MAINE YANKEE ATOMIC POWER COMPANY •

Subject: Maine Yankee Proposed Technical Specifications for 10 CFR 50,  
Appendix R

In response to your request, Reference (c), enclosed is additional information regarding the Maine Yankee diesel generator fuel oil storage and transfer systems.

APPENDIX R DIESEL GENERATOR OIL PIPING

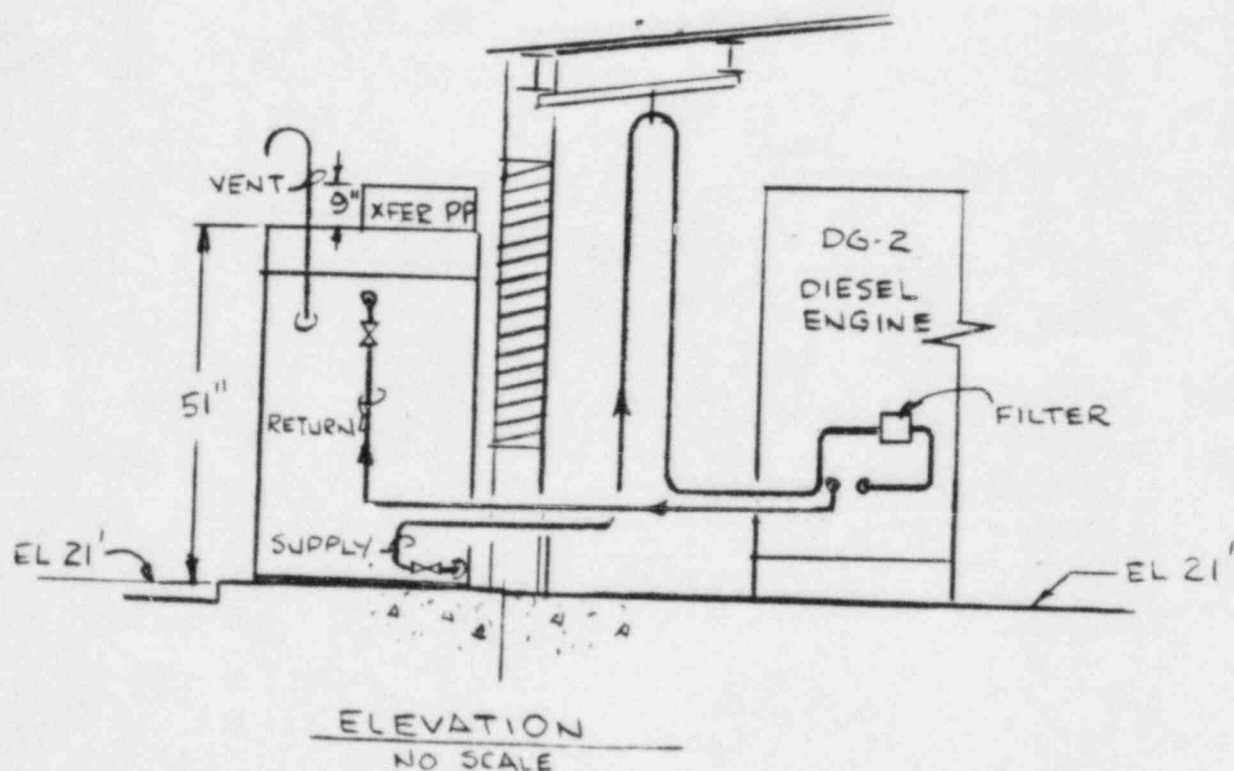
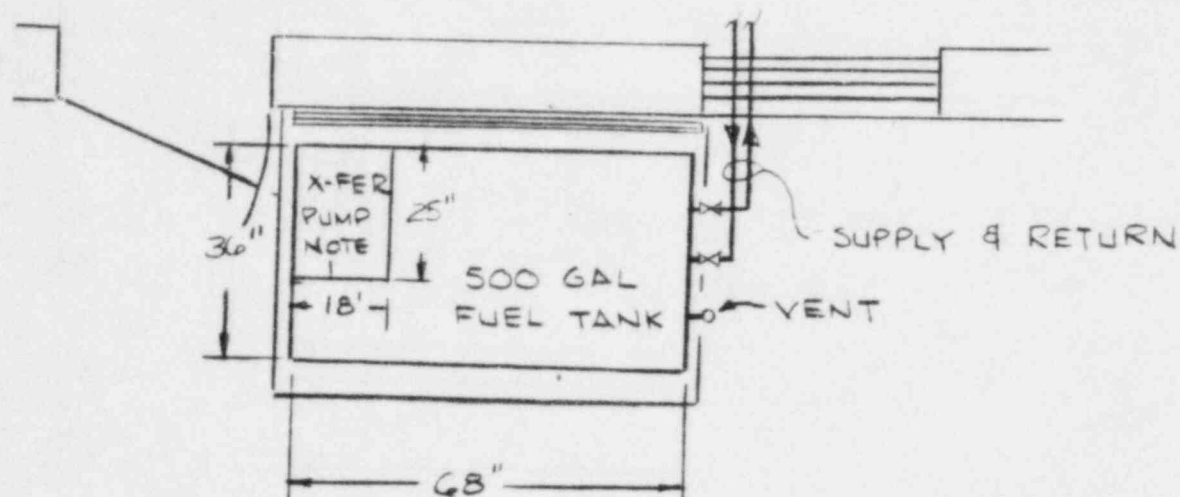
Item (e) of your request for additional information deals with the classification of the piping and components for both the emergency diesel generators and the alternate diesel generator. The emergency diesel generators are classified as Safety Class 3, and the alternate diesel generator is classified as non-nuclear safety (NSS) class. The emergency diesel system is not normally connected to the alternate diesel system. The systems would only be connected by a temporary hose in an emergency to refill the fuel oil day tank for the alternate diesel generator.

NOTE 1. NO PERMANENT CONNECTION BETWEEN APPENDIX R DIESEL AND THE EMERGENCY DIESELS. APPENDIX R DIESEL TANK MAY BE REFILLED IN EMERGENCY BY CONNECTING TRANSFER PP ON 500 GAL TANK TO MANWAY ON UNDERGROUND TANKS VIA TEMPORARY TYGON TYPE TUBING.
